Task Force SAFE

Inspection-Report_TFSAFE_F797V_Camp-Echo-Ground-Floor-Office-RLB_113_24-1 2-25_1-2

Base Location	Erbil (Iraq)	Date:	2025-12-24
Base Code	F797V	Team #:	113
Building #	Camp-Echo-Ground-Floor-Office-RLB	System Voltage	230/400
Building Type	Administrative	Inspection Phase	Initial Inspection
Previous Report #:	N/A	Work Order:	TFS-F797V-2025-00046

Deficiency #1**RAC 2****Occurrences: 1**

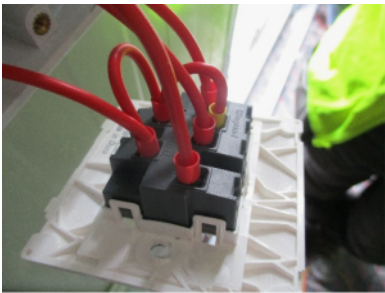
Description: There is no ground cable to light switches.

Location:	By back exit door
Category:	Grounding and Bonding
Equipment:	WLT
Imminent:	No
Action:	N/A
Code:	BritishStandard 542: Earthing arrangements
Status:	Open
